CONTRACT CHANGE ORDER NO. ____
SHEET ___ OF ___

MARK	DATE	DESCRIPTIONS	BY	CH'D	CCO#
1	04/18/12	EAST END OBG	MN	GB	87

SAN FRANCISCO OAKLAND BAY BRIDGE
EAST SPAN SEISMIC SAFETY PROJECT
SELF-ANCHORED SUSPENSION BRIDGE
(SUPERSTRUCTURE & TOWER)

FLOORBEAM AT EAST TRANSITION NO. 1

PP 117 (Shown) & PP 117.5 (Similar) (See Note 1)

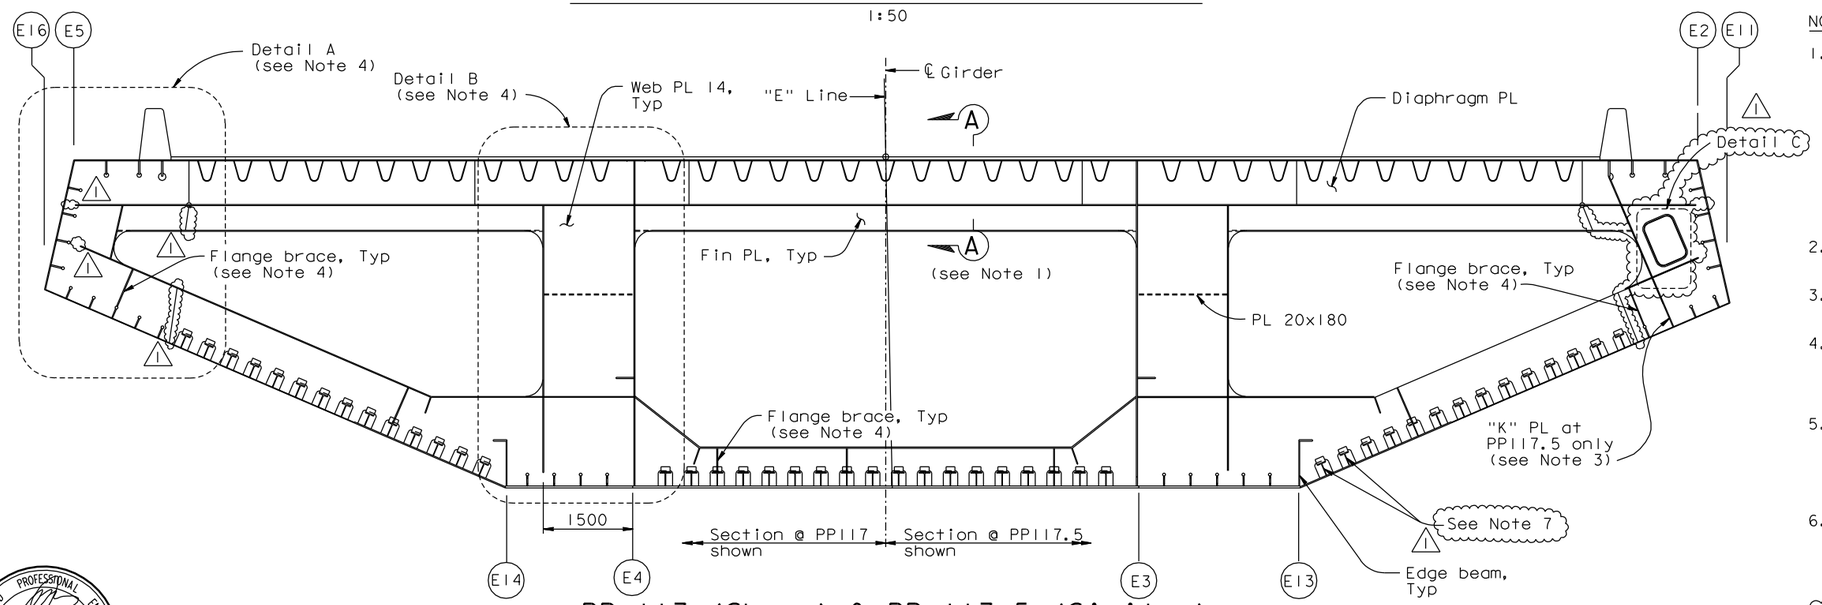
7. For the two adjacent WT stiffeners at PP117.5, it is acceptable to use an enlarged cutout, subject to review and approval of the Engineer.
